From: [Peter Butler](#)
To: [CouncilHearing \(CI-StPaul\)](#)
Subject: Written comments for May 24, 2023 hearing
Date: Thursday, May 18, 2023 10:56:52 PM
Attachments: [Summit Bike Lane Comments 05-24-2023.pdf](#)

May 24, 2023, Public Hearing – Submitted Comments

Questions about Parks and Rec's proposed plan for Regional Trail on Summit Avenue

Example 1

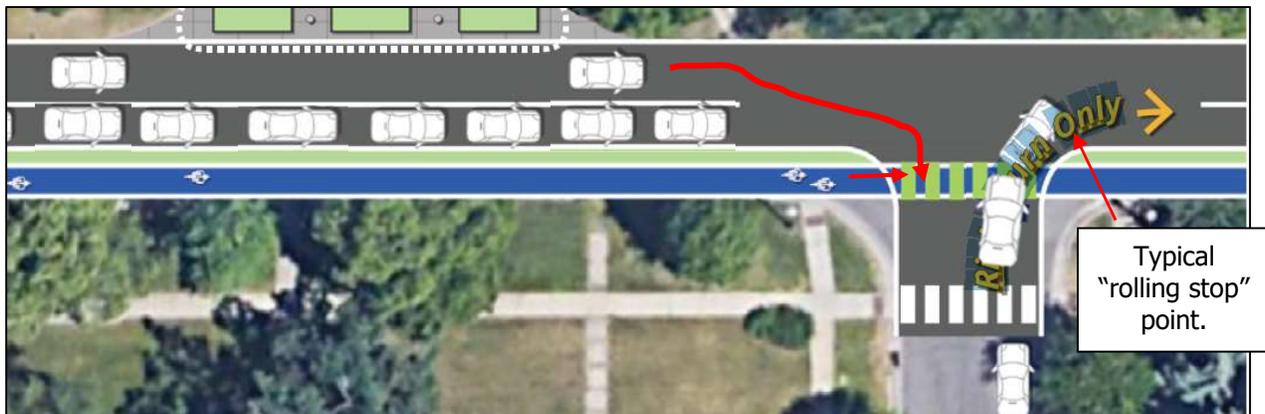
I modified this 90% bike plan image¹ to show more parked cars and a line of turning vehicles from cross streets. Drivers on Summit turning right may not see nor stop for bicycles. Both cars and bikes are moving and bikes can suddenly appear in front of a car and vice versa.

Many drivers do not stop behind the stop sign but pull well into Summit to see around parked cars. Other cars waiting to turn will encroach on the bike lane.

Example 2

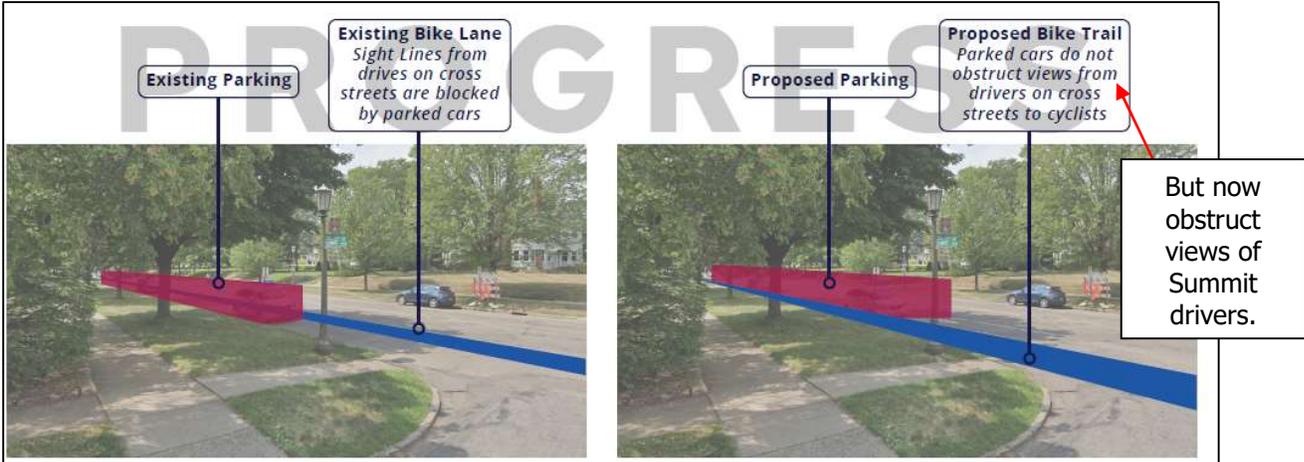
The proposed solution on the right worsens sight lines for drivers on Summit. Bicyclists are obscured behind parked cars. The bike path is closer to where cross-street traffic enters Summit, narrowing distance between bikers and the "rolling stop" point.
